**FINAL DRAINAGE REPORT
FOR
PLATTE SELF STORAGE
COLORADO SPRINGS, COLORADO**

MAY 2024

Please include project No.
PPR2418

PLATTE SELF STORAGE SITE DEVELOPMENT PLAN PROPOSED DETENTION POND MAY 2024

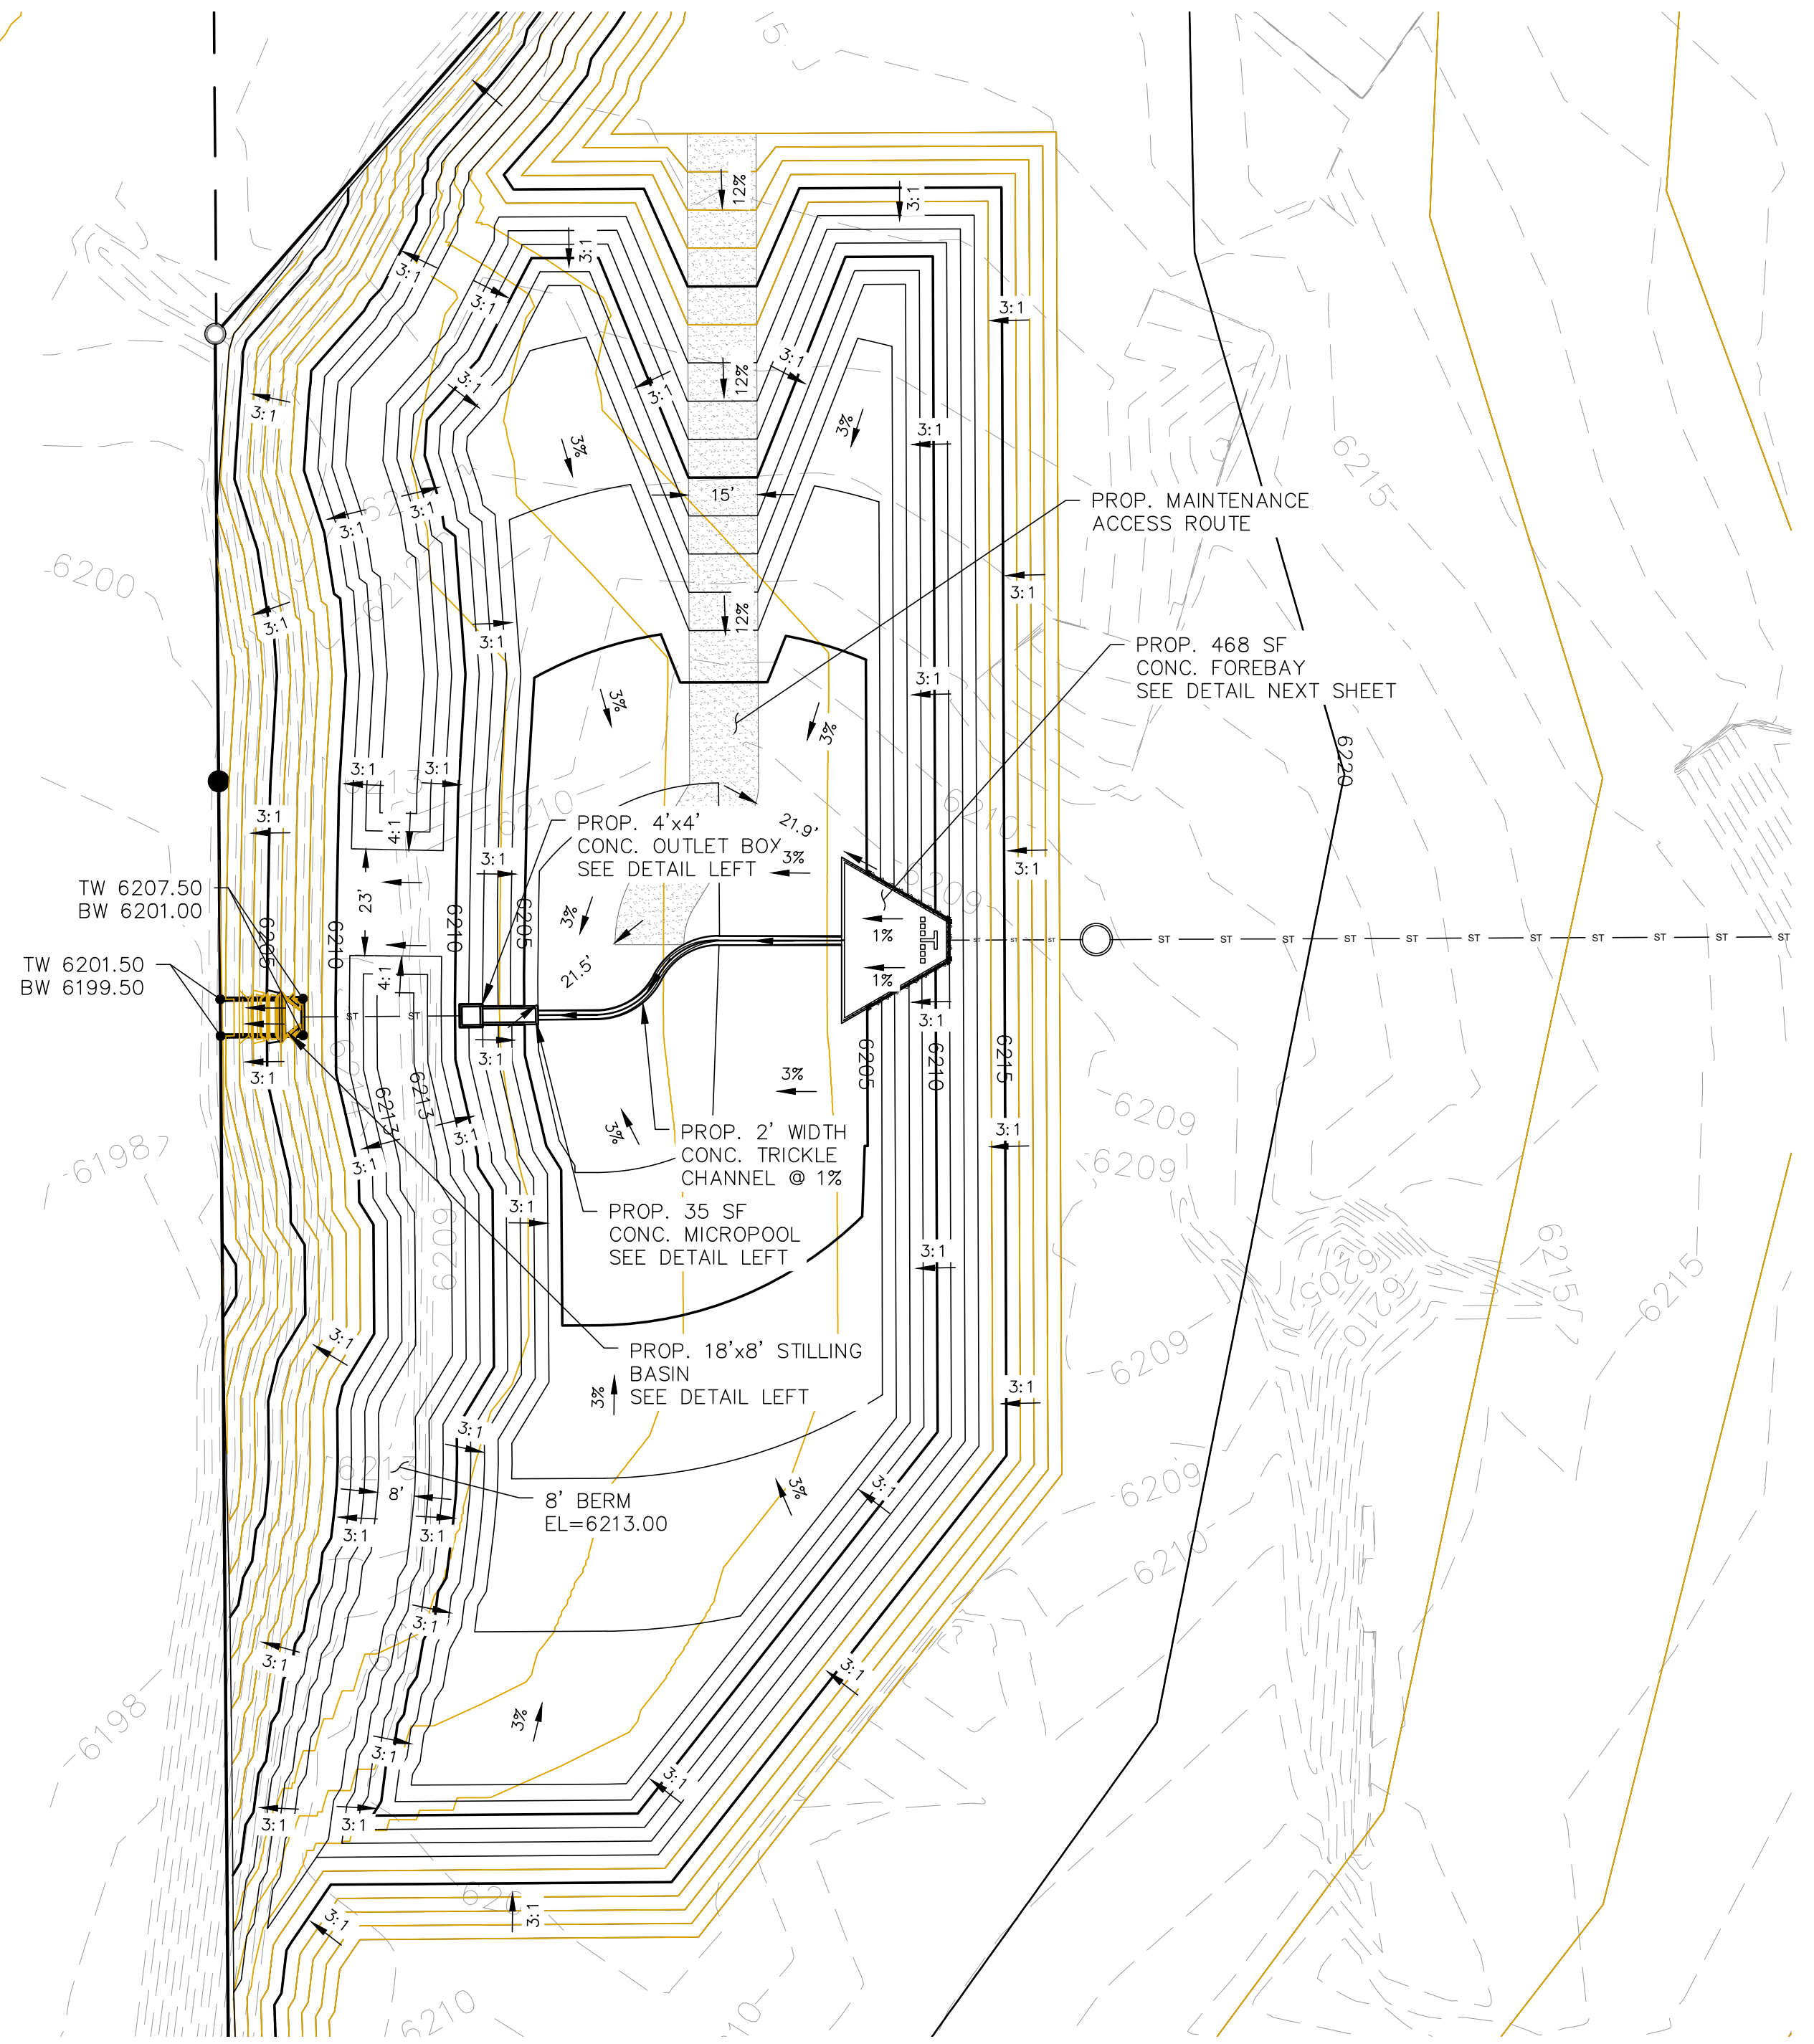
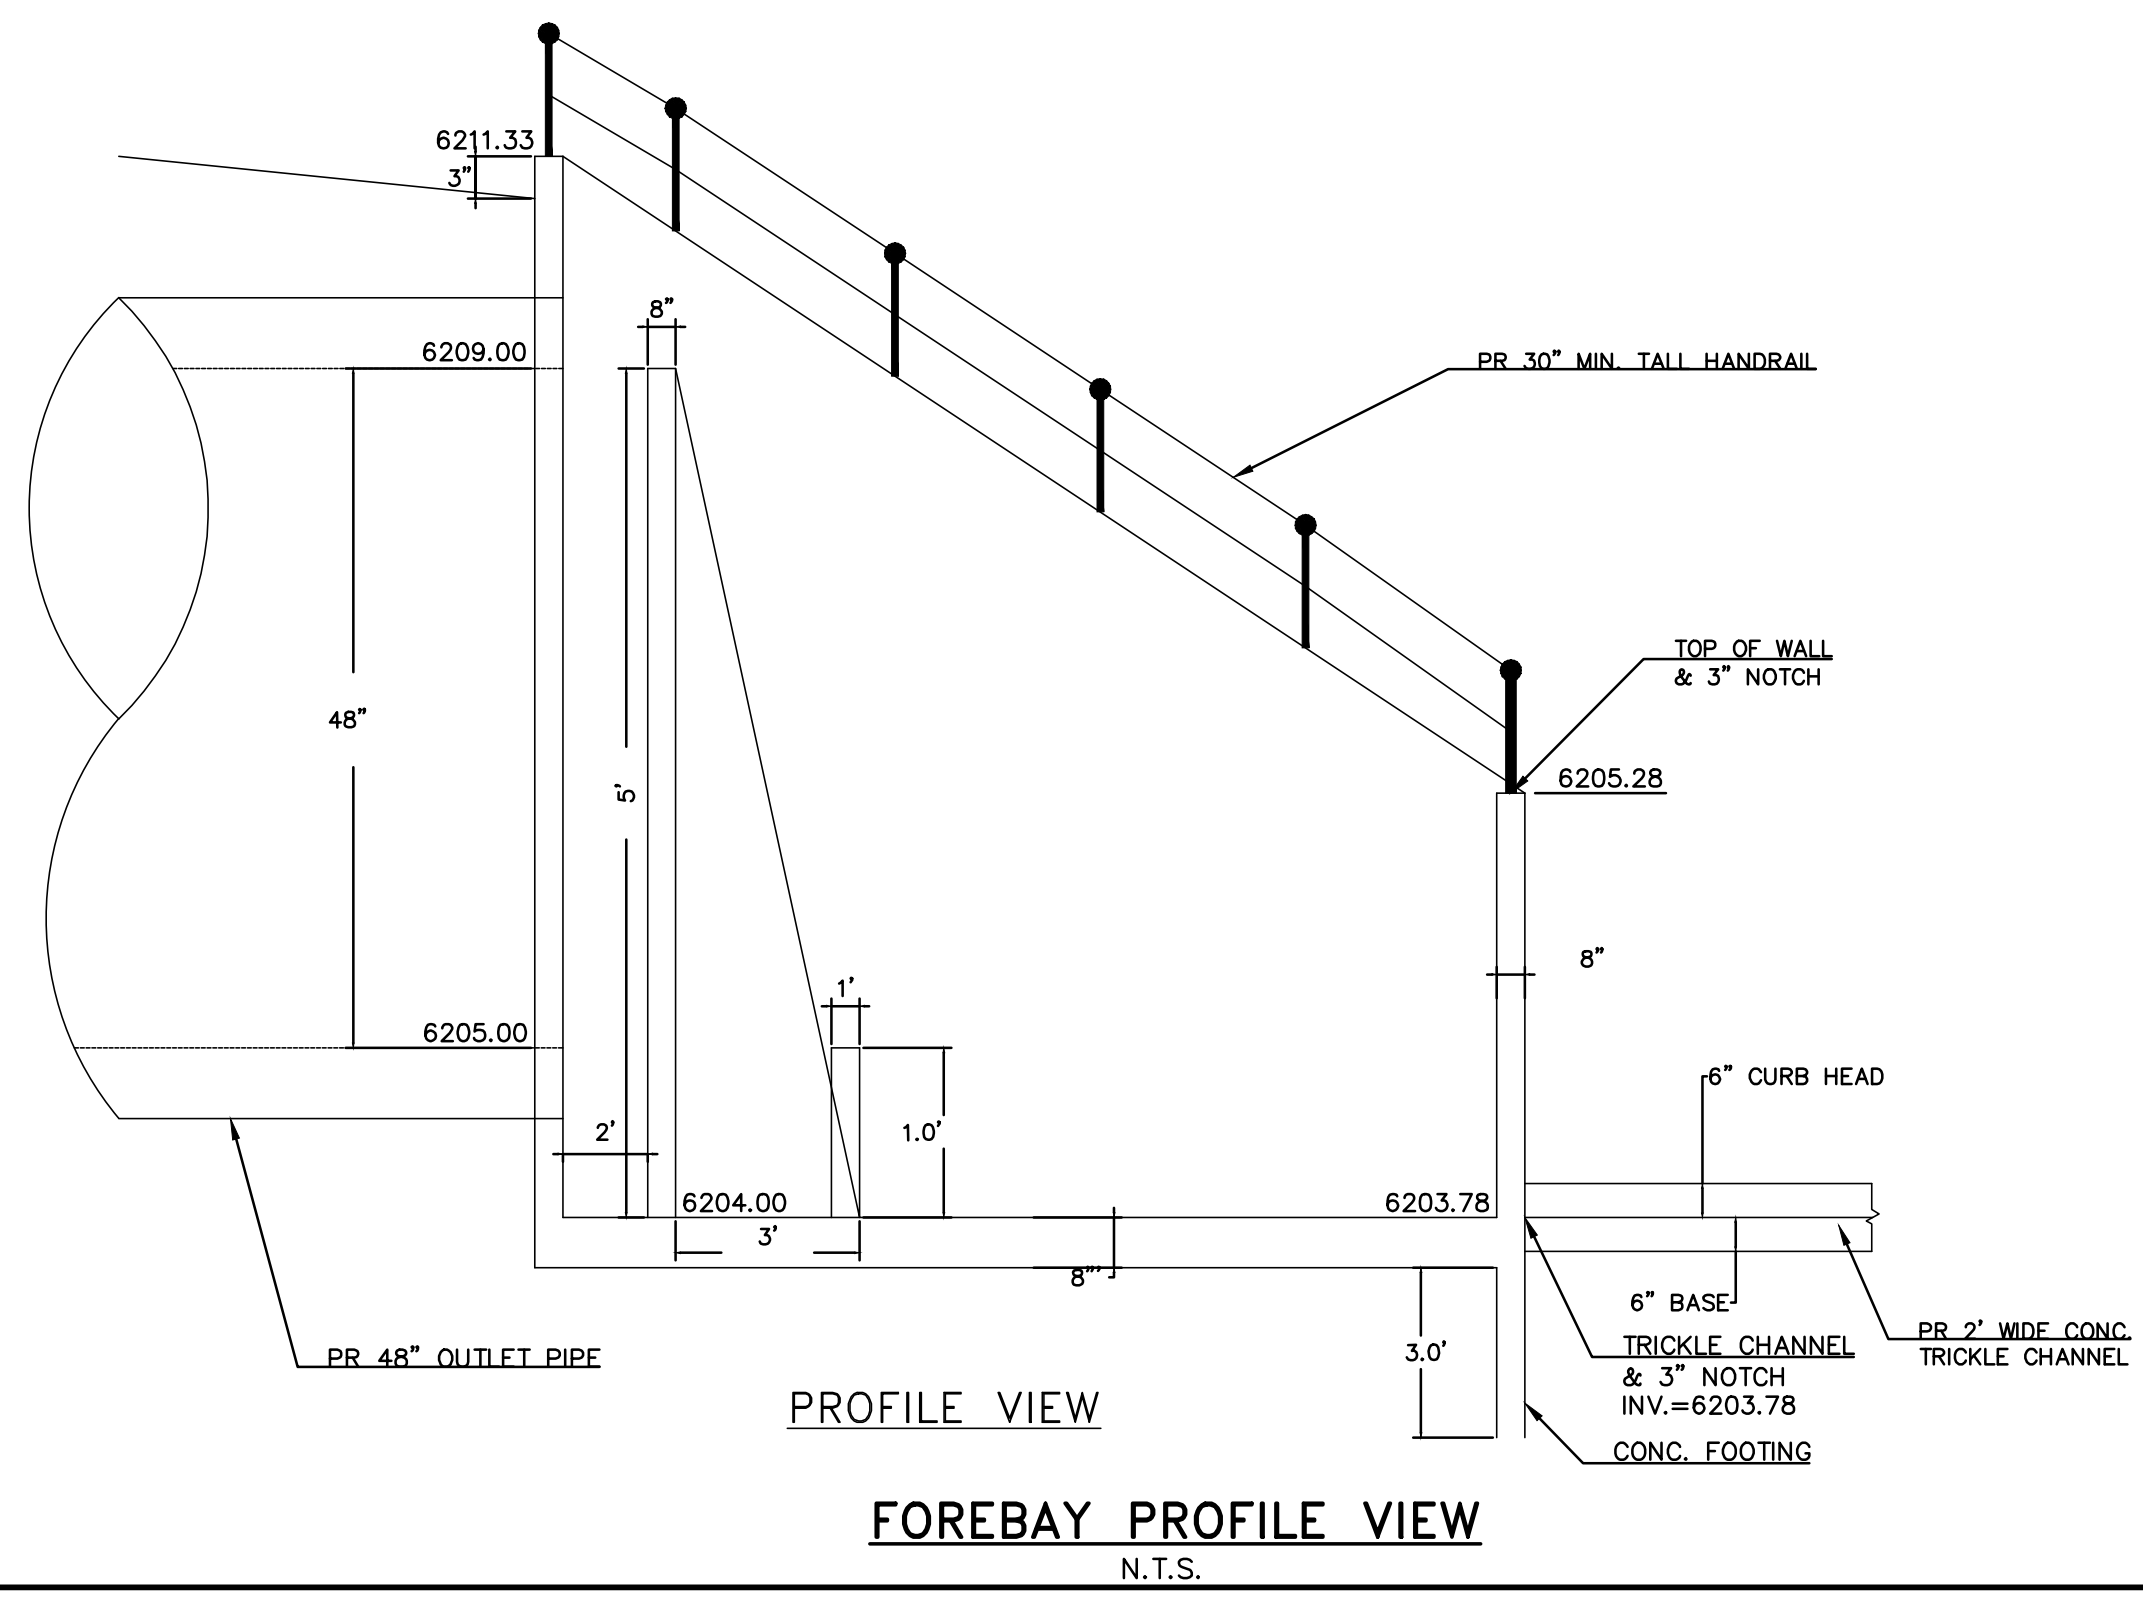
Construction plans are not reviewed within the drainage report. Please remove.
